# CONSTRUCTION COMMITTEE MEETING AGENDA

**DATE:** **Tuesday, December 5, 2023**
**TIME:** **1:30 p.m.**
**PLACE:** **Carl T. Langford Board Room / Orlando International Airport/ One Jeff Fuqua Blvd. / Orlando, FL 32827**

# CONSTRUCTION COMMITTEE MEETING
# CHANGE ORDER AGENDA
## Tuesday, December 5, 2023

B Graphic View
Scale is 1" = 8"

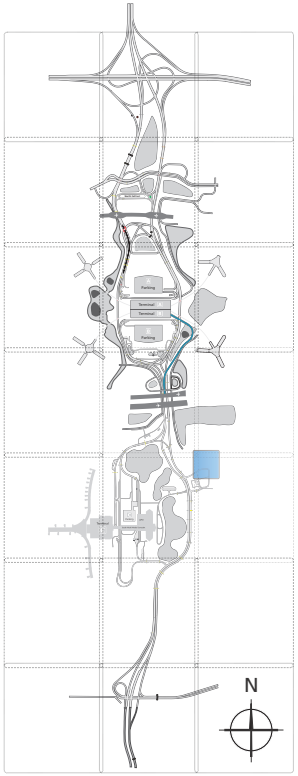
Remove "Authorized Vehicles Only" and Replace with Above Option

1,2 Elevation View
Not to Scale

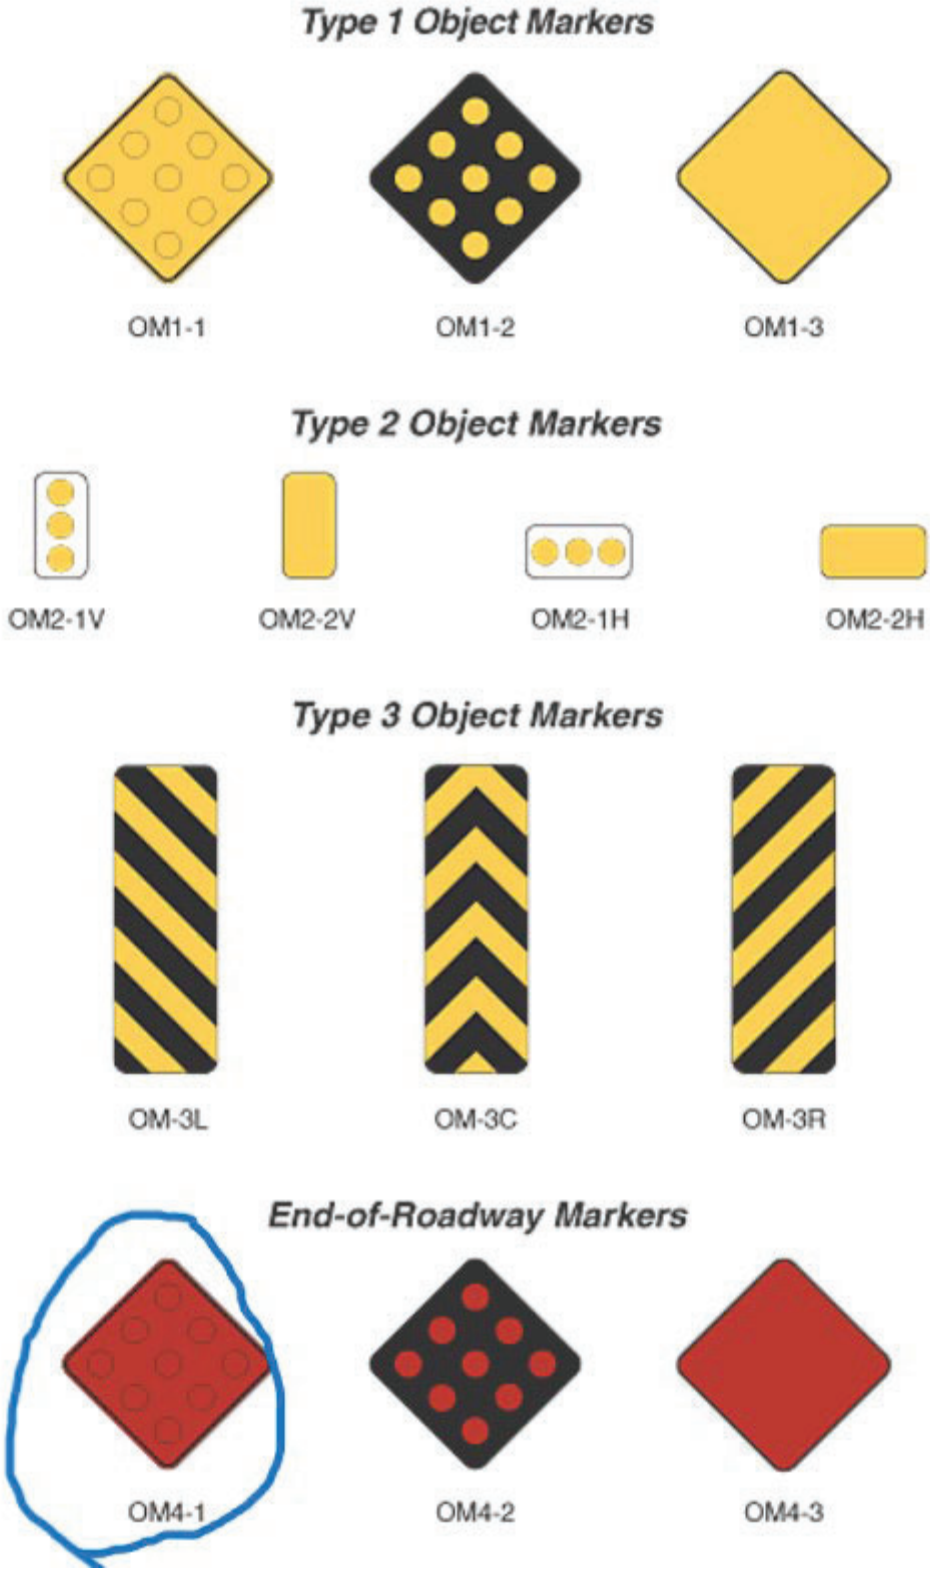
Add Employee Exit to overhead is structure allows?

**Figure 3C-1. Object Markers and End-of-Roadway Markers**

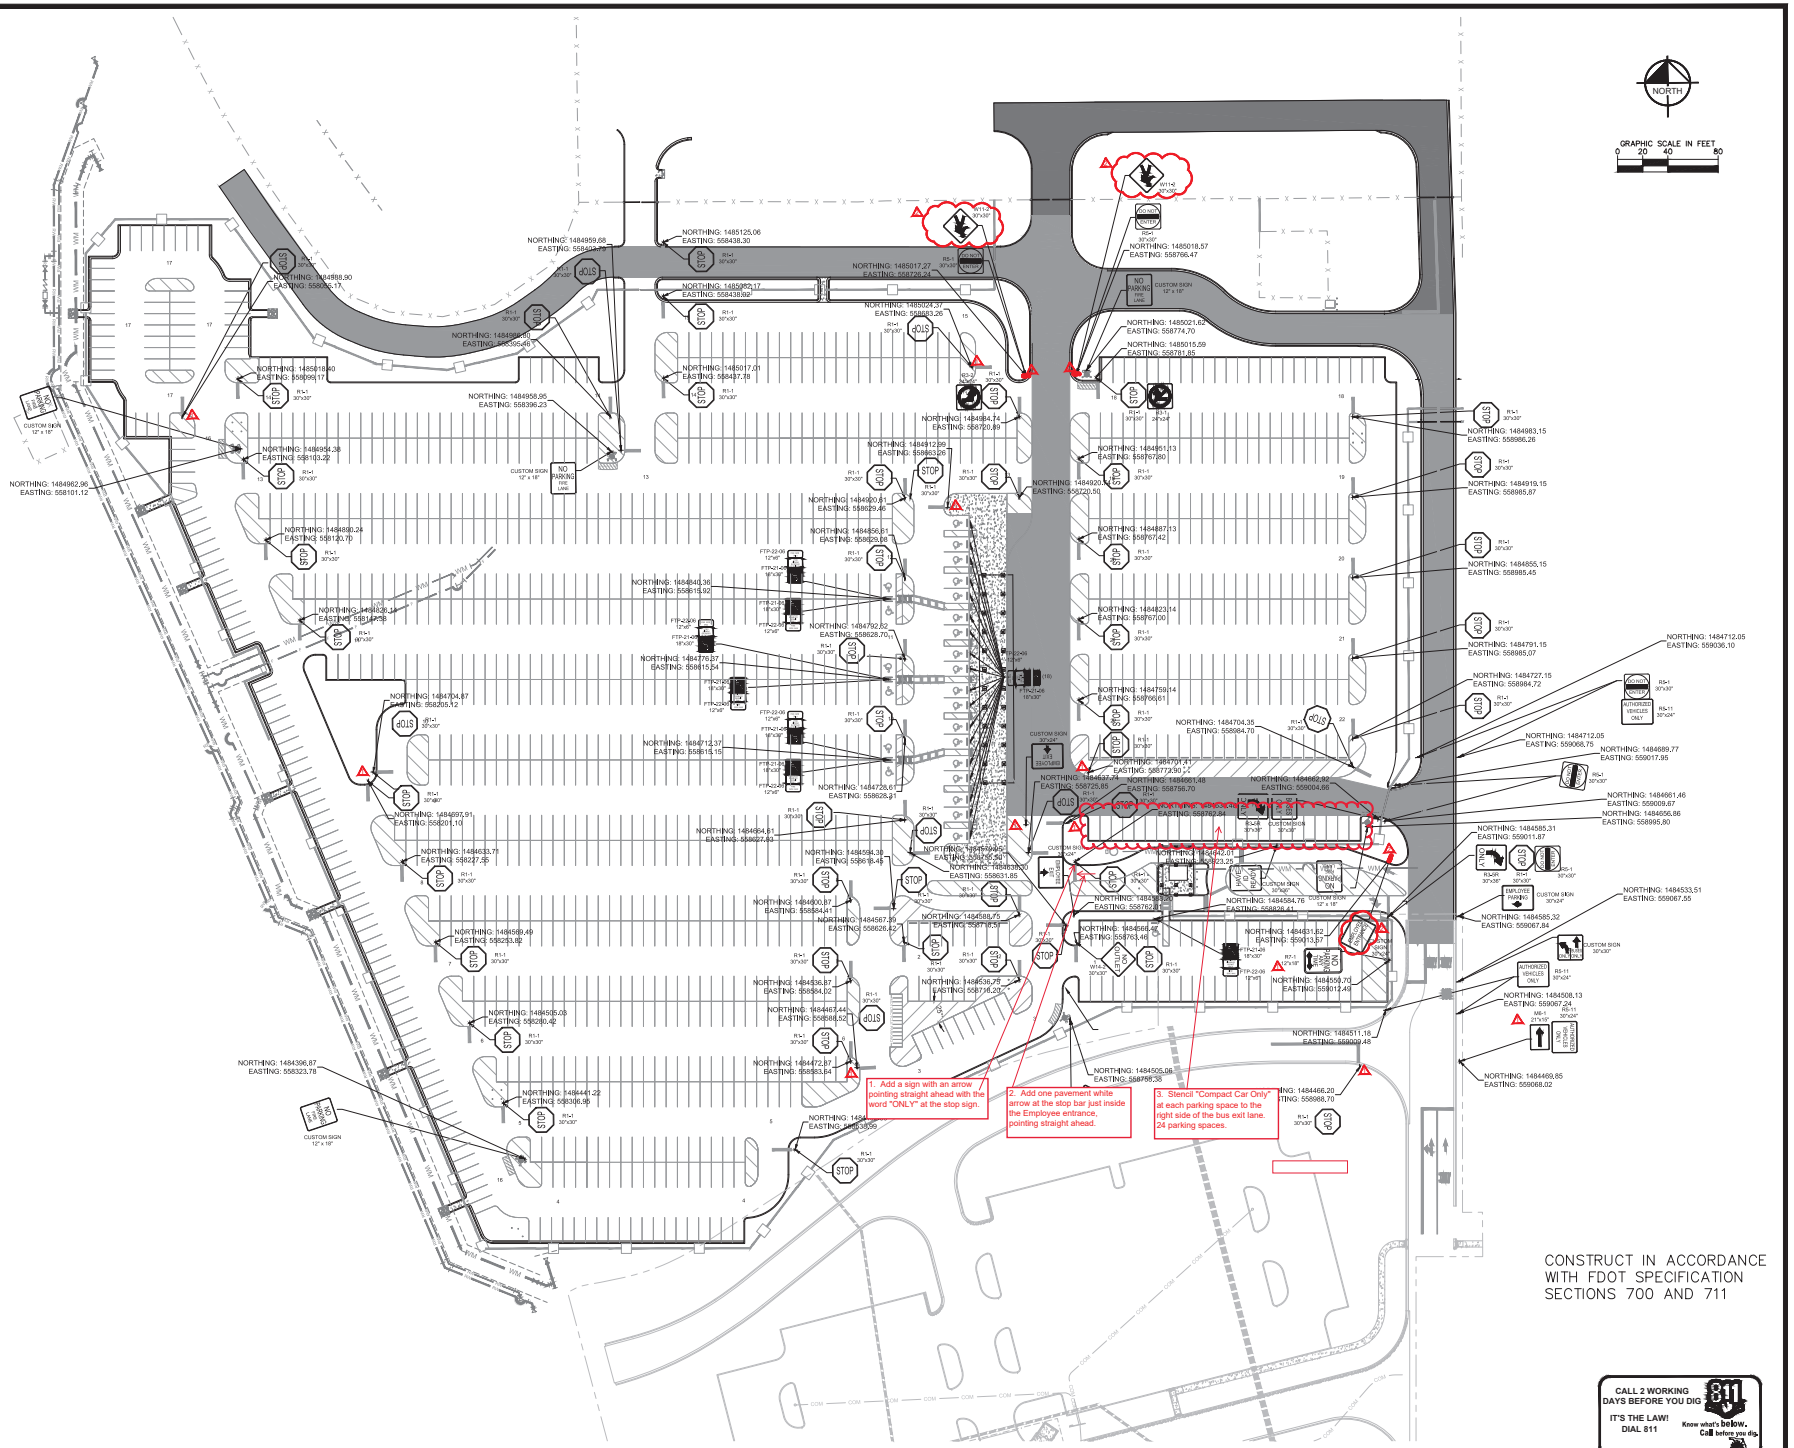
The red color would stand out during the day and at night the reflectors would be very visible. They would also function as typical end of roadway signage and be easy to obtain as a standard MUTCD sign.

# Plan: HYATT 4TH FLOOR HOT WATER REPLACMENT#0005.pdf

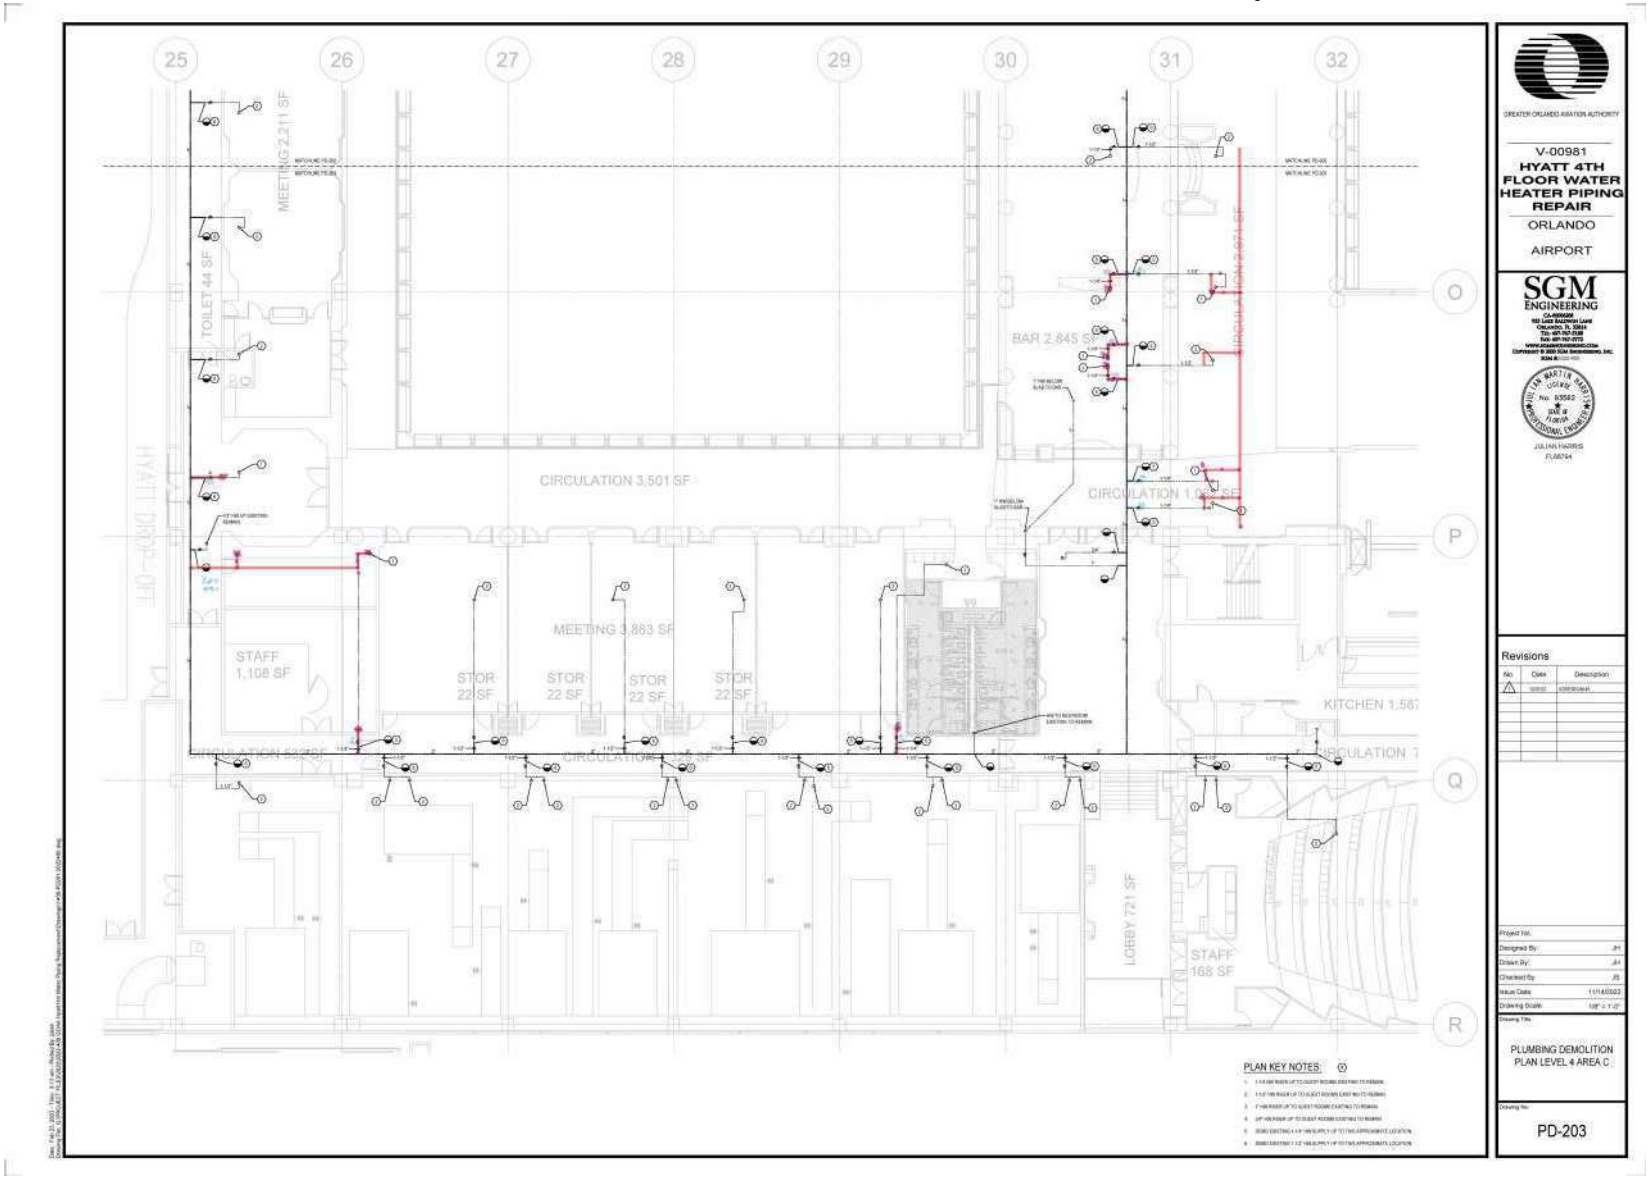
ADD A 1" CONNECTION NOT ON DRAWING
